PLANNING AND ZONING CASE CHECKLIST

P&Z CASE # P2019-010 P&Z DATE 3/26/19 CC DATE 4/1/2019 APPROVED/DENIED _____
ARCHITECTURAL REVIEW BOARD DATE _____ HPAB DATE _____ PARK BOARD DATE _____

Project Number P2019-010	Owner RW LADERA, LLC	Applied 3/14/2019	LM
Project Name Lot 1, Block A, & Lot 1, Block B, Ladera	Applicant G&AI MCADAMS	Approved	
Type Rockwall		Closed	
Subtype FINAL		Expired	
Status Staff Review		Status	
 Site Address 900 N JOHN KING BLVD		City, State Zip ROCKWALL, TX 75087	
		Zoning	
Subdivision LADERA ROCKWALL	Tract 5	Block	Lot No 5
			Parcel No 0122-0000-0005-00-OR
			General Plan

PLANNING COMMENTS - DAVID GONZALES - 03.21.2019

FINAL PLAT
 Lot 1, Block A &
 Lot 1, Block B
LADERA ROCKWALL
 47.694 Acres
 Zoned: PD-85
 in the
 M. JONES SURVEY, ABSTRACT NO. 122
 CITY OF ROCKWALL
 ROCKWALL COUNTY, TEXAS

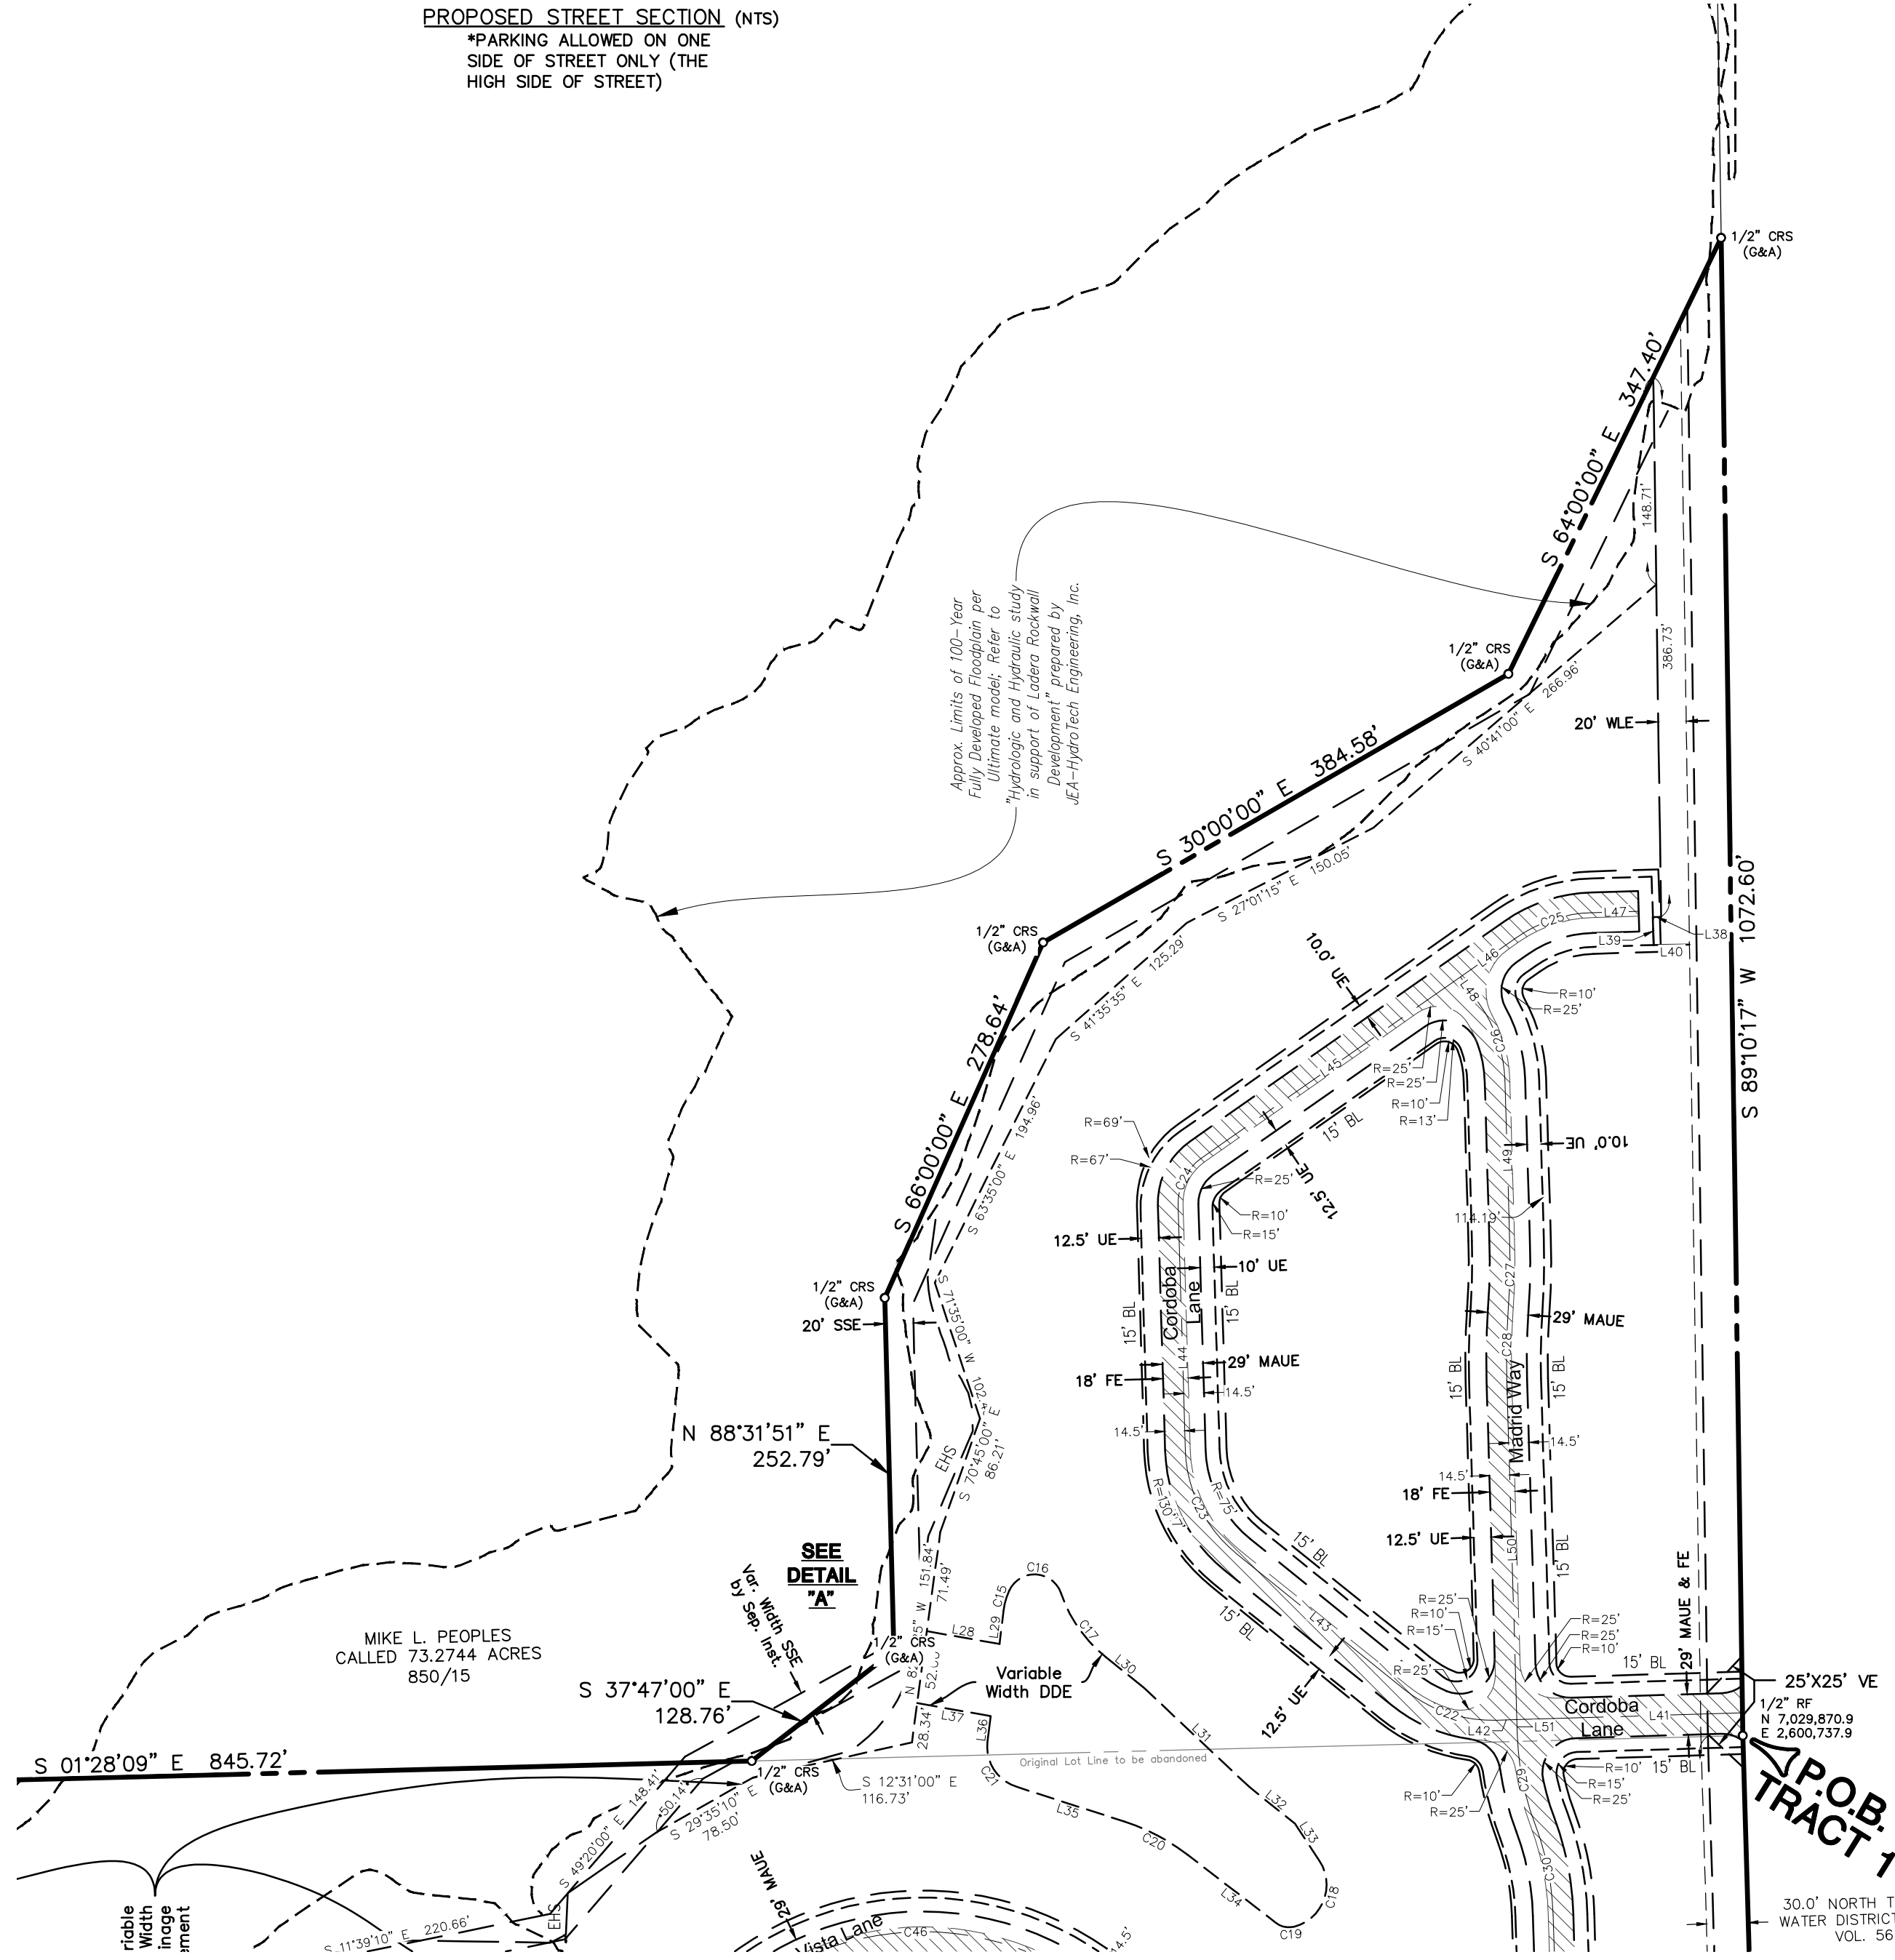
5. Where are the streets Lugo Ct. and Meridia Ct.? These do not appear on page 2 of the plat.
6. Provide a label and information for SH-66 on page 2 of plat.

1. Provide street name labels for Lugo Ct. & Meridia Ct.

DETAIL "A"
 Scale: 1"=30'

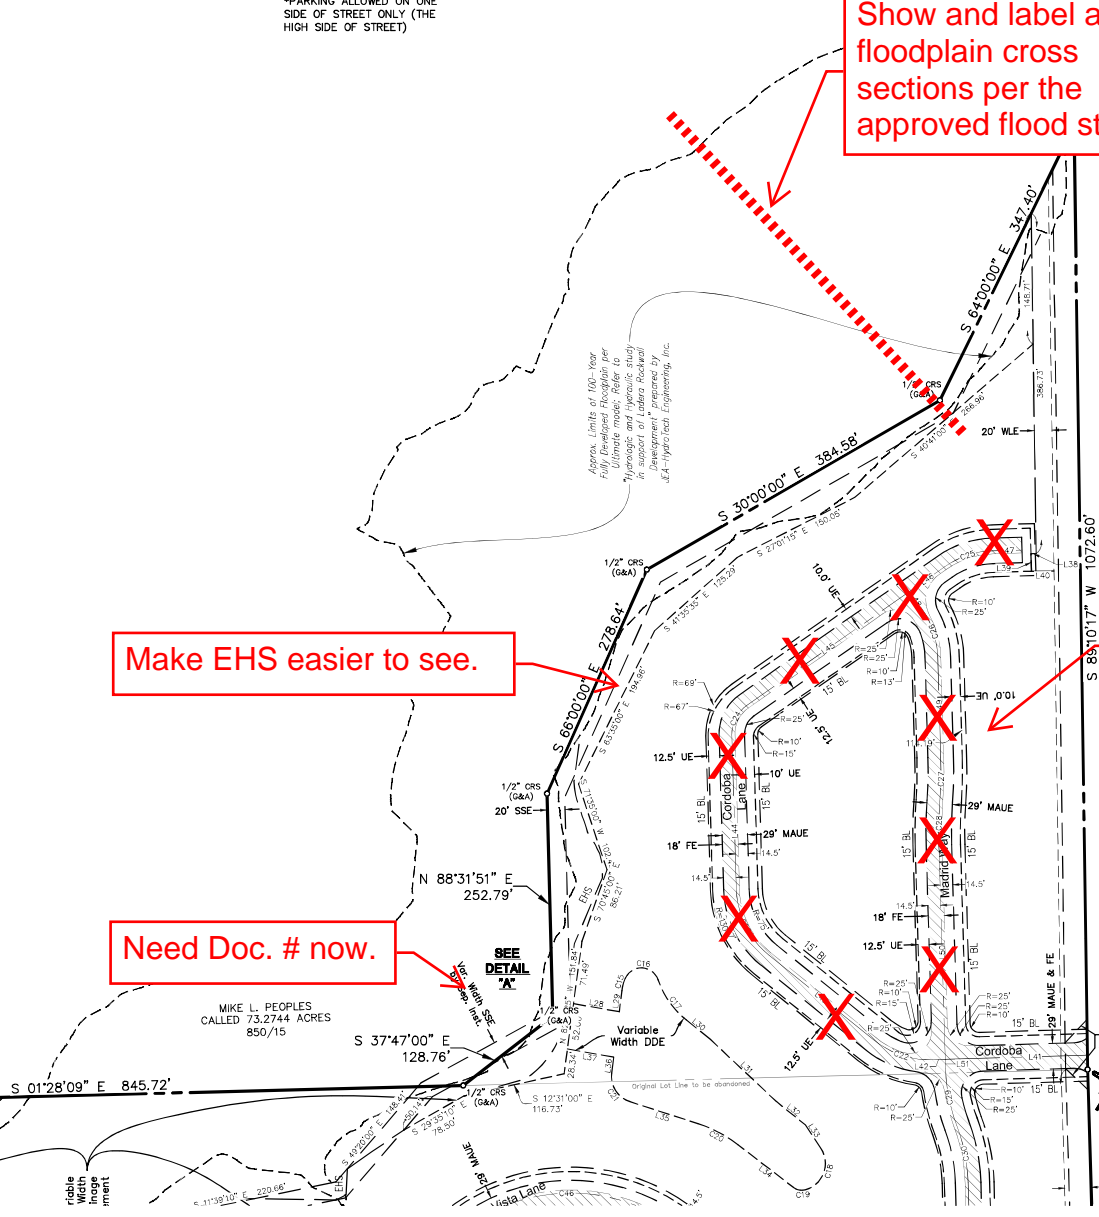
Show and label all floodplain cross sections per the approved flood study.

Remove all of the easements for Phase 2.
